PERMIT

SEWAGE DISPOSAL SYSTEM

MARYLAND STATE DEPARTMENT OF HEALTH

ADDRESS 3445 Apt. B Plum Tree Drive, Ellicott City, Md.

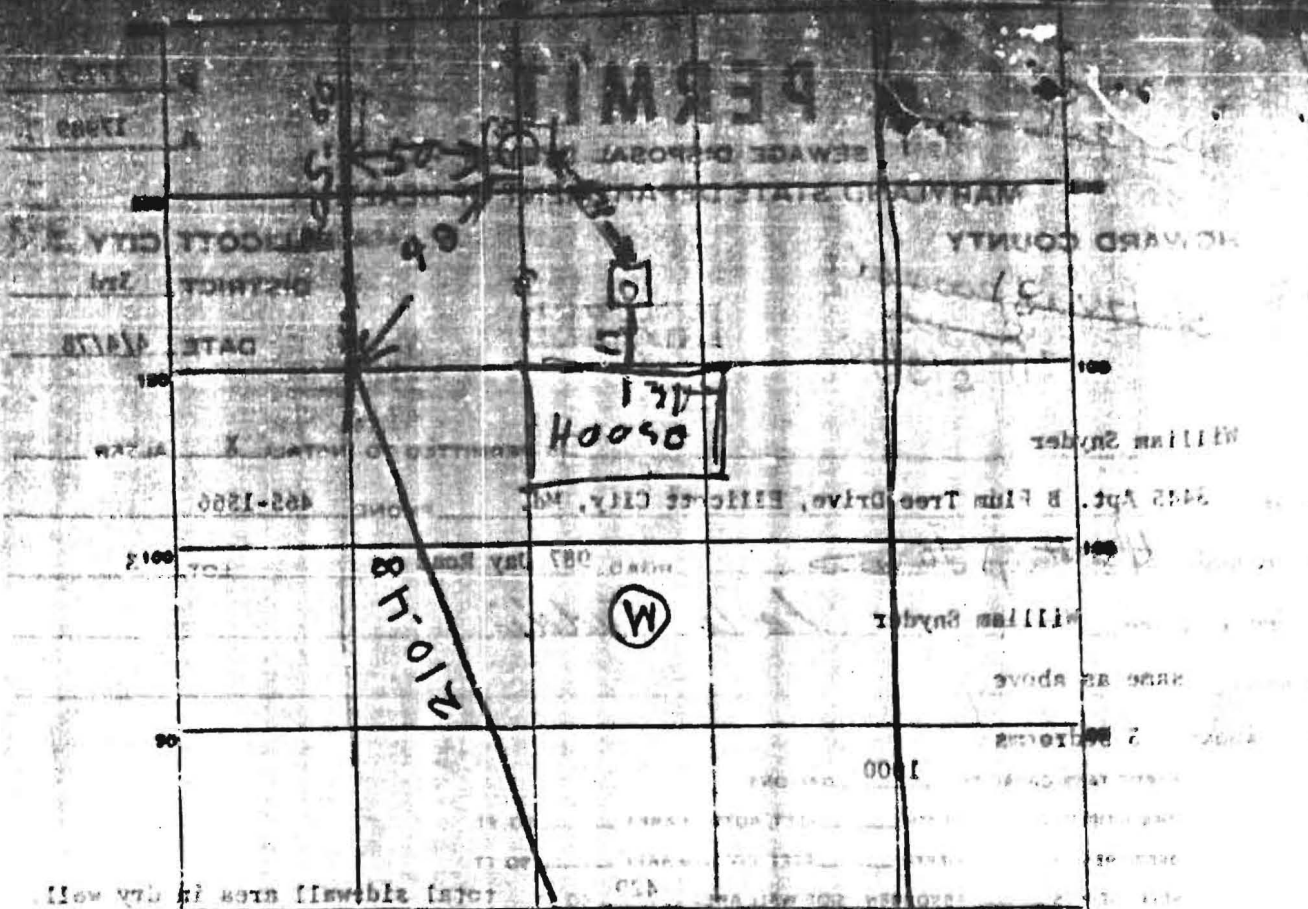
REMARKS 4/27/78 AM - UNCERTAIN IF LOCATION OF DW IS
RIGHT. OWNER MUST MEET & SHOW INSPECTOR WHERE
LOT LINES LOCATED. SEPTIC TANK HOUSE
SEWER OK. DRYWELL INCOMPLETE R/H
4/27/78 AM LOCATION OK MET WITH OWNER, OK TO COVER
TANK & HOUSE SEWER. CALL FOR INSPECTION OF DRYWELL INLET & CLEANOUT
